Access Compliance Report

Public Rights-of-Way

Intersection ID: 18921	Main Street: LUMARKA_DR	Cross Street: PEBBLERIDGE_DR	Location: E
ADA ID: E3070613977C	Ramp Type: Directional1	Initial Pass/Fail: Fail	Overall Compliance: No
		Severity Score: 12.5

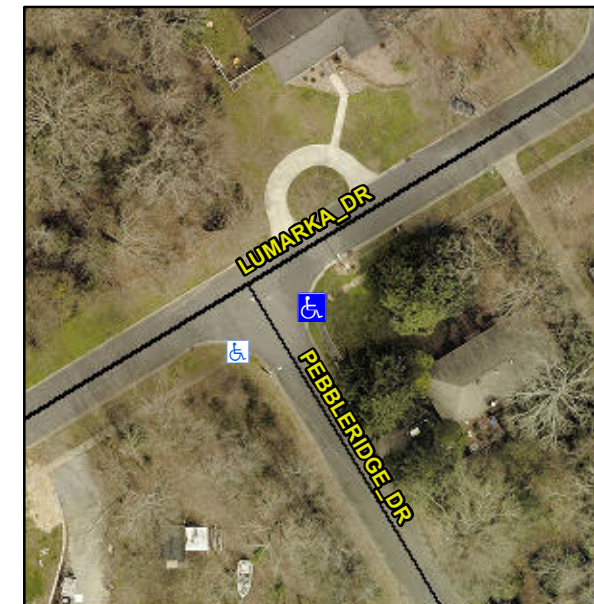
R304.2.2

Compliance	Description	Data	Compliance	Description	Data
N/A	Ramp Length (in)	96.0	N/A	Grade Break?	N/A
Yes	Ramp Width (in)	48.0	N/A	Grade Break Slope (%)	0.0
No	Ramp Slope (%)	8.4	N/A	Grade Break XSlope (%)	0.0
Yes	Ramp XSlope (%)	1.2			
N/A	Flare Type LT	N/A	N/A	Flare Type RT	N/A
N/A	Flare Slope LT (%)	N/A	N/A	Flare Slope RT (%)	0.0
N/A	Flare Traversable LT?	N/A	N/A	Flare Traversable RT?	N/A
N/A	Landing Length (in)	0.0	N/A	DWS Provided?	N/A
N/A	Landing Width (in)	0.0	N/A	DWS Contrast?	N/A
N/A	Landing Slope (%)	0.0	N/A	DWS Length (in)	N/A
N/A	Landing X Slope (%)	0.0	N/A	DWS Full Width?	N/A
N/A	Landing Curb? (Y/N)	N/A	N/A	DWS Offset LT (in)	N/A
N/A	Shared Landing?	N/A	N/A	DWS Offset RT (in)	N/A
N/A	Gutter Ponding?	0.0	N/A	Gutter Slope (%)	N/A
N/A	Gutter Lip Ht (in)	0.0	N/A	Gutter X Slope (%)	N/A
N/A	Painted X Walk1?	No		Road Slope (%)	4.3
	X Walk 1 Direction	To SW		Road X Slope (%)	6.0
	X Walk 1 Width (in)	N/A		Clear Space?	N/A

Remove & Replace Entire Ramp.
